Final Environmental Impact Report for the

Roseville Environmental Utilities Operations Center Project

State Clearinghouse No. 2024060953

ERRATA SHEET TO THE FINAL ENVIRONMENTAL IMPACT REPORT

Figure 2-1 Project Site and Surrounding Conservation Land

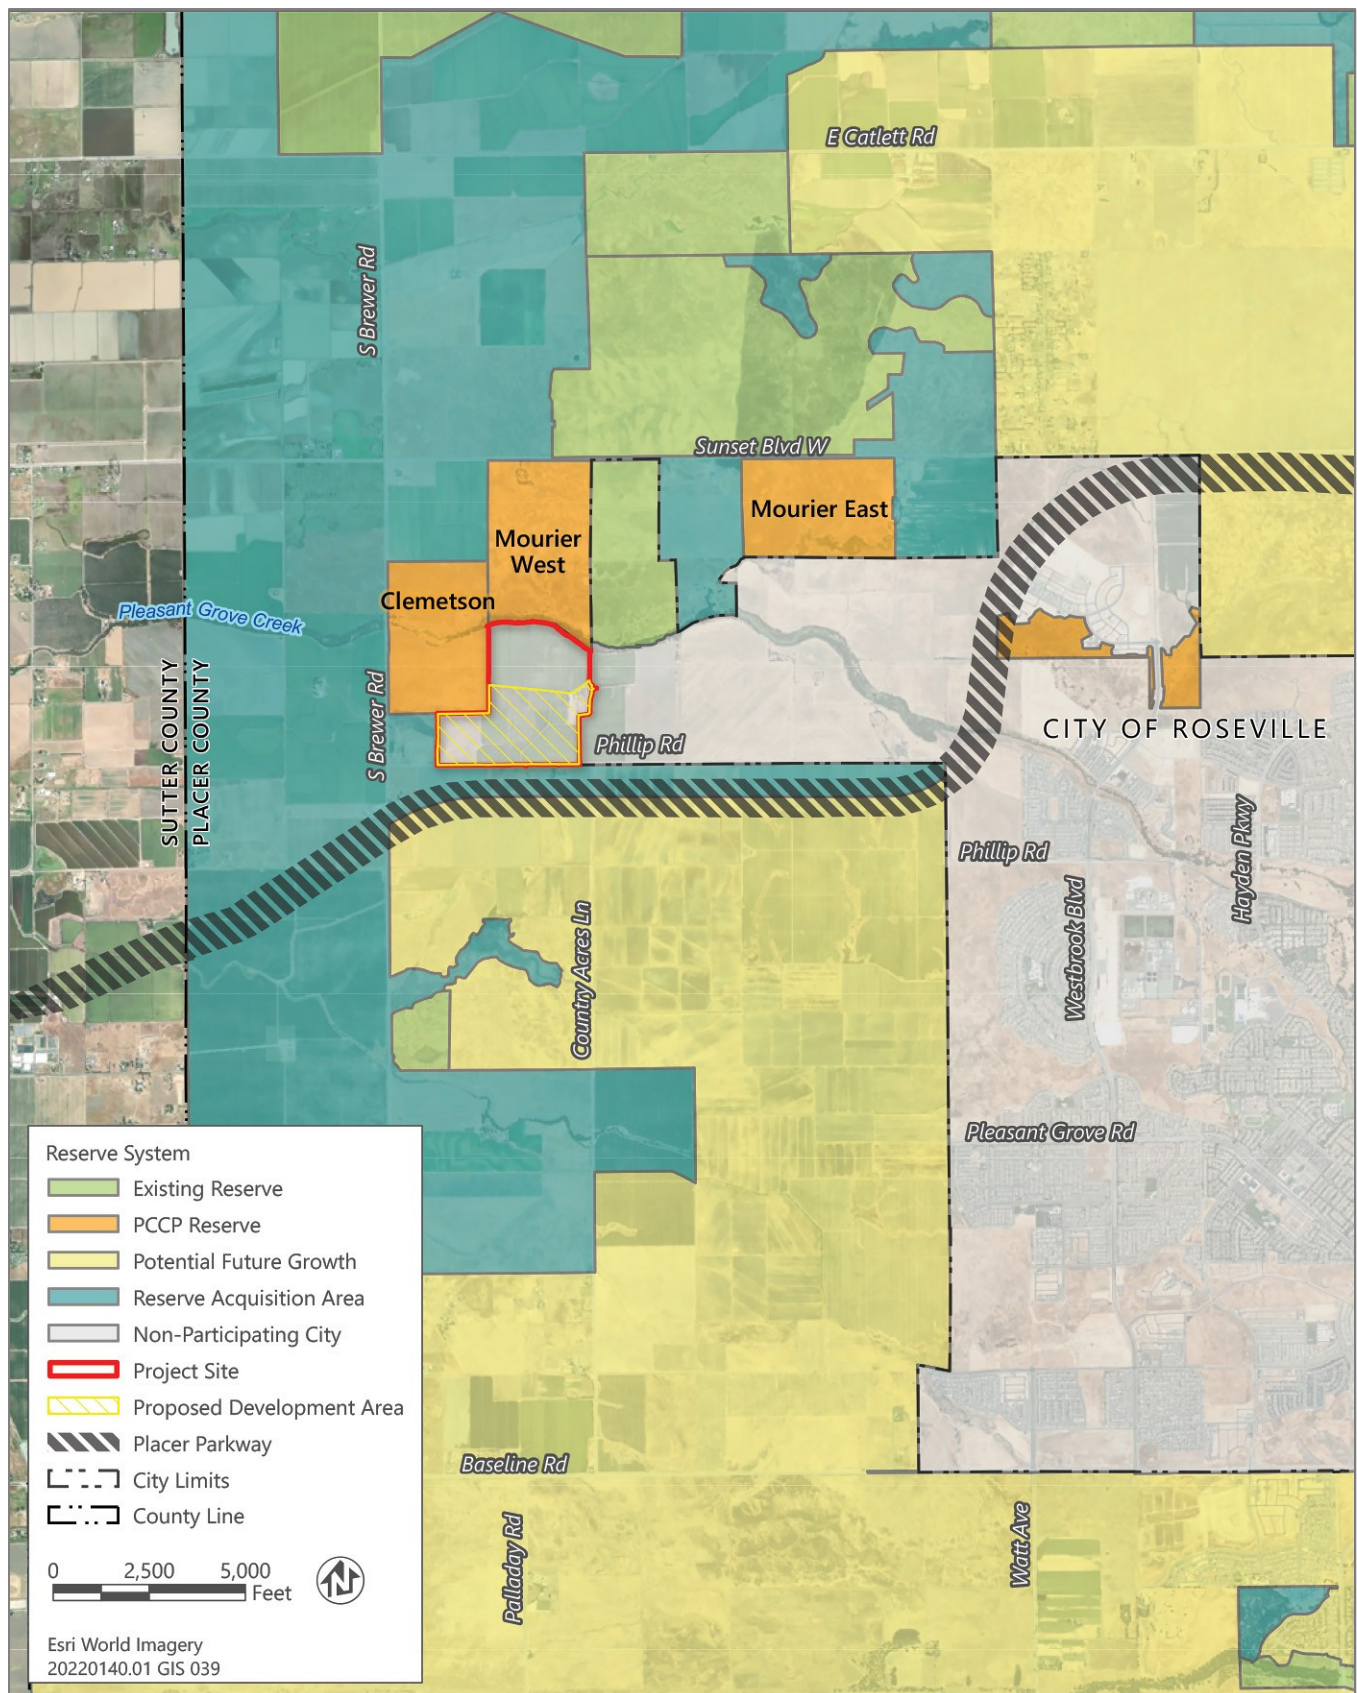
Recommendation or Recommended Mitigation Measure: Because the Project site is bordered by the PCCP RAA and existing reserve lands, CDFW recommends that the DEIR be revised to include a discussion of each Project alternative's consistency with the PCCP and how the City will ensure that implementation of the Project alternatives do not impede the PCCP's ability to meet its permit conditions and biological goals and objectives. Particular focus in the DEIR's analysis should be directed to:

- ▶ Analysis of potential impacts to all PCCP Covered Species.
- ▶ Assessment of project impacts to natural communities and constituent habitat types identified in the PCCP.
- ▶ Identification of applicable PCCP avoidance, minimization, or mitigation measures.
- ▶ Discussion of any inconsistencies between the Project and the PCCP.

The comment states that the Draft EIR does not adequately address the project's proximity to lands protected under the Placer County Conservation Program (PCCP). The comment states that the project site is adjacent to PCCP reserve lands and recommends that the EIR evaluate consistency with the PCCP, analyze potential impacts to PCCP-covered species and habitats, identify applicable avoidance and mitigation measures, and discuss any inconsistencies between the project and the PCCP. As stated in the Draft EIR, the project site is not located within the PCCP plan area, and the City is not a participant in the PCCP. Accordingly, the project is not subject to the PCCP's permit requirements, conservation strategy, or mitigation framework.

The City acknowledges that portions of the lands adjacent to the project site were added to the PCCP reserve system after the City issued the NOP and conducted its biological fieldwork, and provide habitat values that contribute to the PCCP conservation network. Figure 2-1 in this Final EIR shows the project site in relation to the surrounding PCCP reserve system mapped in 2026.

Figure 2-2 Potential Wetlands on the Clemetson Property (West of the Project Site)

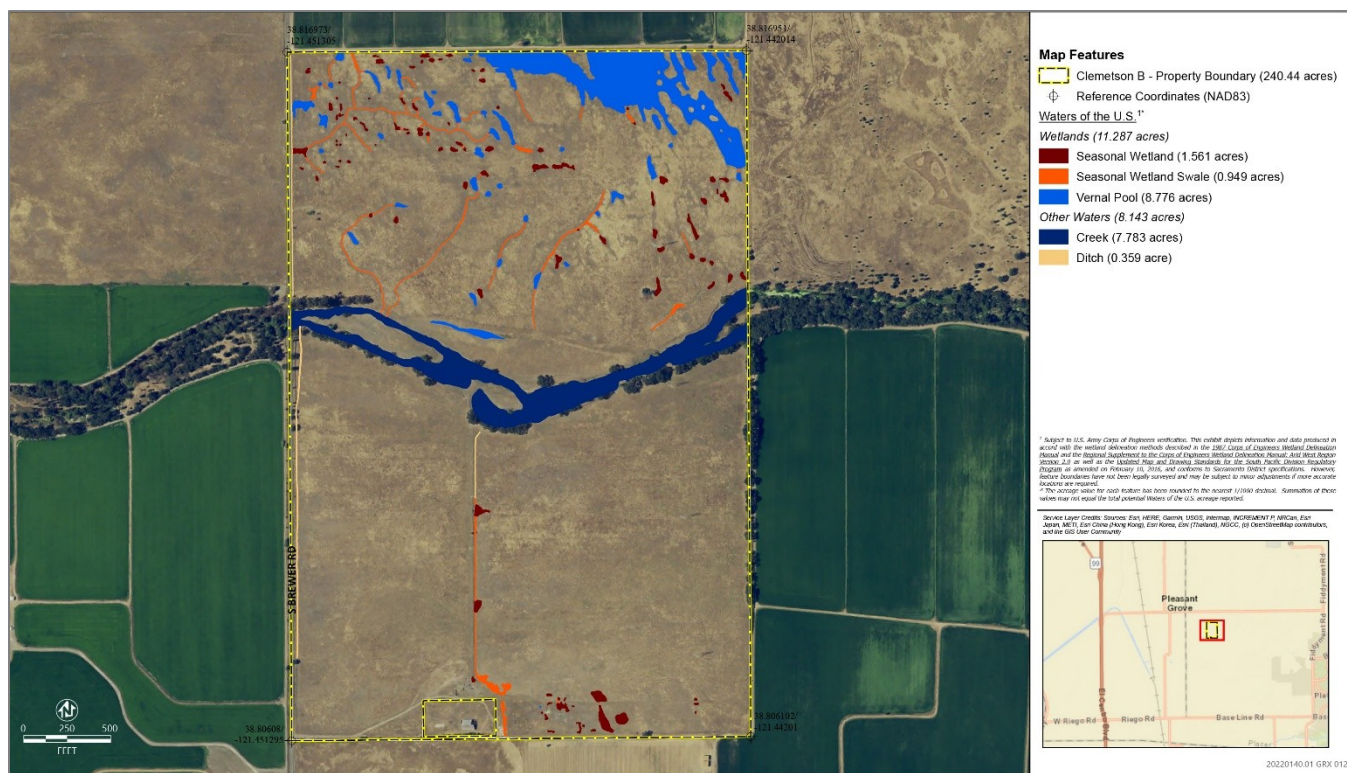
To identify any potential inconsistencies with the PCCP and provide special emphasis on rare or unique resources in compliance with CEQA, CDFW recommends the EIR also address the following:

- ▶ Impacts to established or future reserve lands managed under the Placer Conservation Authority (PCA).
- ▶ Reduction of available reserve lands in the PCCP (with appropriate buffers and setbacks as detailed in the PCCP).
- ▶ Impacts to PCCP conservation zones and key habitat linkages.

The comment recommends that the EIR evaluate potential effects on the PCCP reserve system, including impacts to existing and future reserve lands, reductions in available reserve lands, and impacts to PCCP conservation zones and habitat linkages. As discussed in the Draft EIR and in response to comment A3-5, the project site is not located within the PCCP plan area and is not subject to PCCP's permit requirements, conservation strategy, or mitigation framework. The Draft EIR evaluates the project's potential direct and indirect impacts on biological resources consistent with CEQA and considers the project's relationship to adjacent habitat areas and other biological resources. The City has concluded that the biological resources analysis adequately addresses the types of impacts identified by the comment and the comment does not provide substantial evidence that the project would result in significant effects to PCCP reserve lands, conservation zones, or habitat linkages beyond those analyzed in the Draft EIR. Accordingly, no changes to the Draft EIR are required.

Figure 2-3 Placer Parkway Alignment Near the Project Site

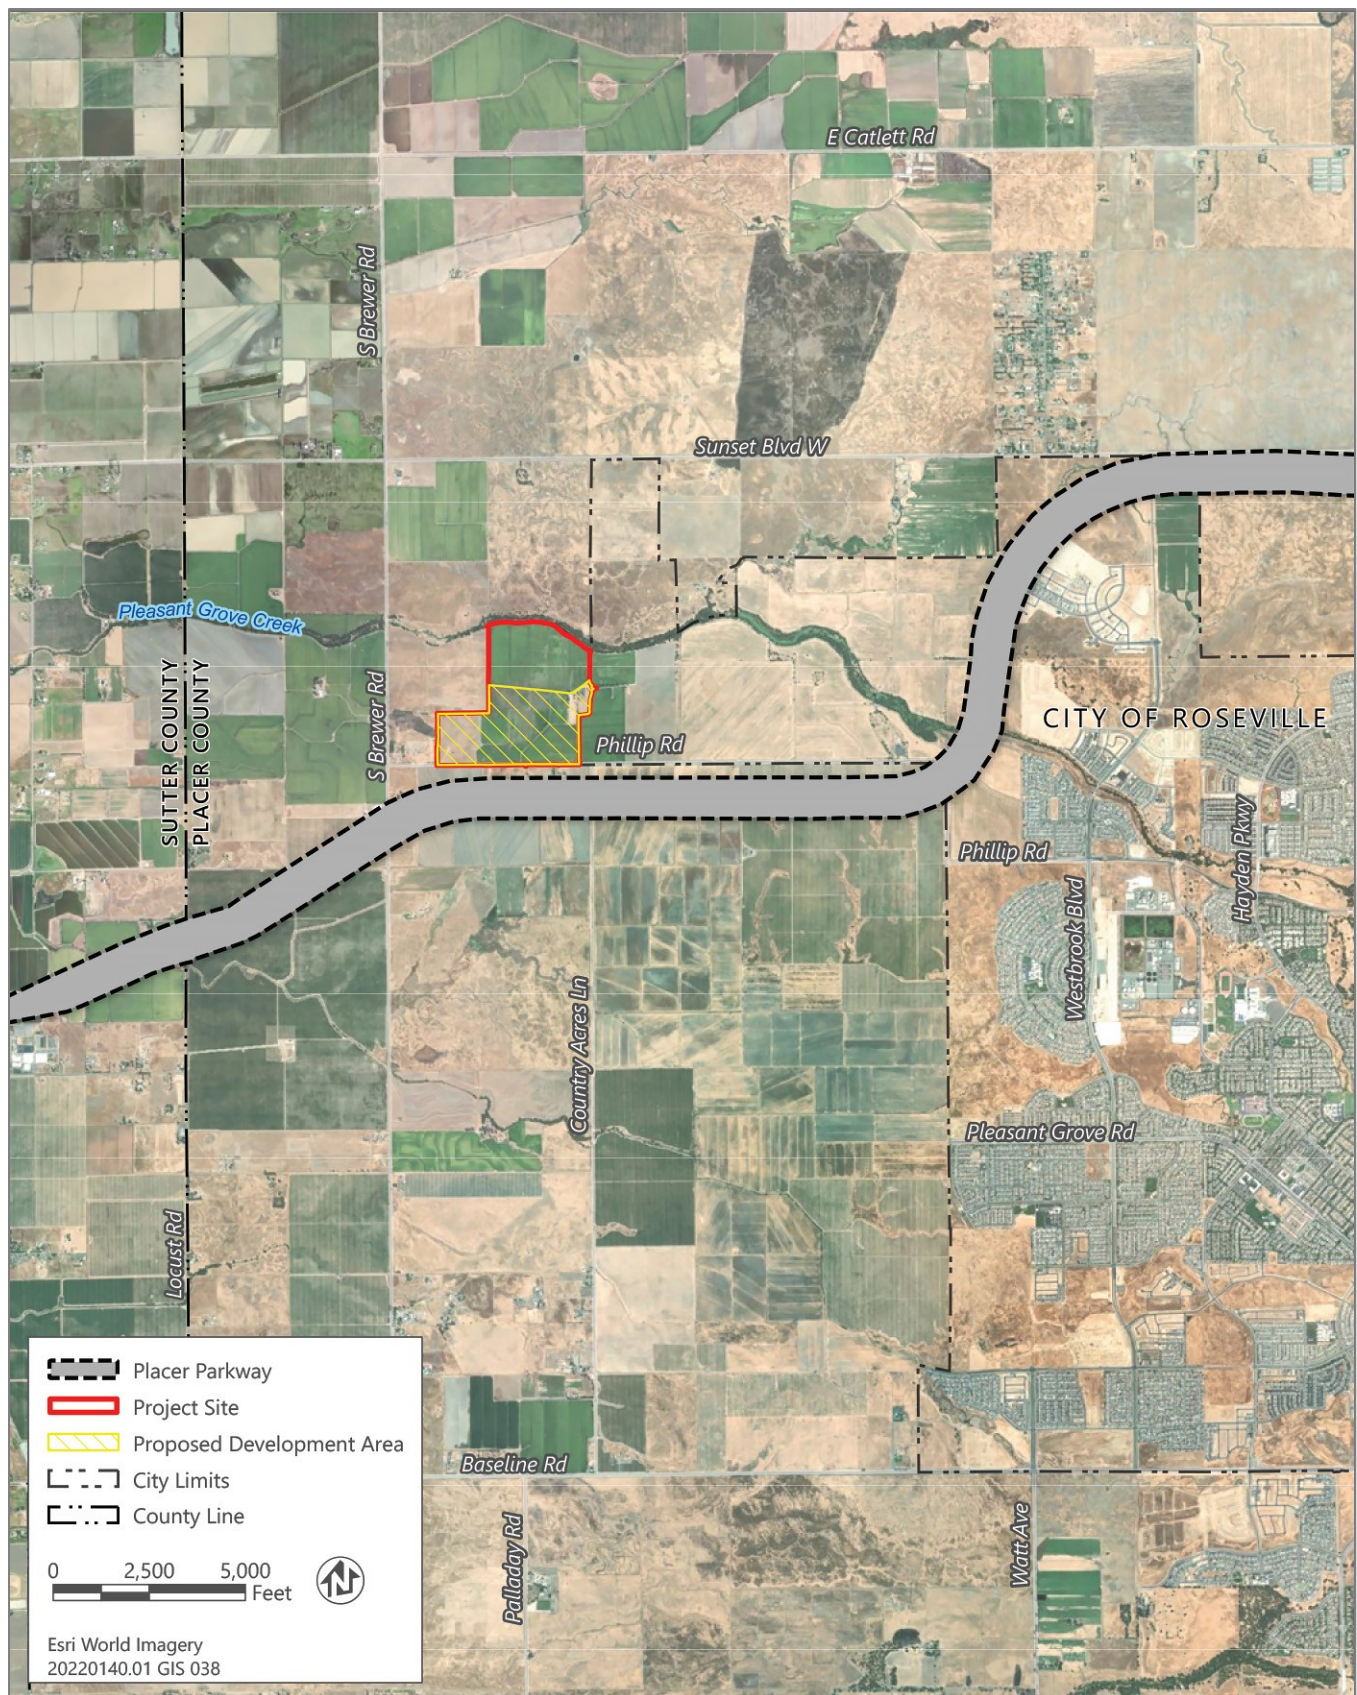
1. The proposed Project is in the vicinity of the approved alignment of the Placer Parkway plan line. As requested in comments following our review of the Notice of Preparation (NOP), the EIR should include an exhibit of the approved plan line for Placer Parkway in relation to the proposed Project. The EIR should also include a discussion of Placer Parkway and identify any impacts that the Project may have on/to the approved Placer Parkway plan line as well as the increased traffic volumes expected on the roadway from this project. The cumulative scenario should include traffic operations analysis of intersections along the Placer Parkway corridor and identify improvements, if needed.

Impacts related to traffic facility operations and level of service (LOS) were removed as a required topic of analysis under CEQA by SB 743 (passed by the California Legislature in 2013 and implemented statewide in 2020). Therefore, the operations-related questions raised by the comment are outside the scope of CEQA. However, the following discussion is provided for informational purposes. The approved Placer Parkway alignment is shown in Figure 2-3 in this Final EIR, in relation to the proposed project. The project site is located on the north side of Phillip Road, and the Placer Parkway planned corridor alignment is 300+ feet south of Phillip Road. Due to this distance, there would be no conflicts.
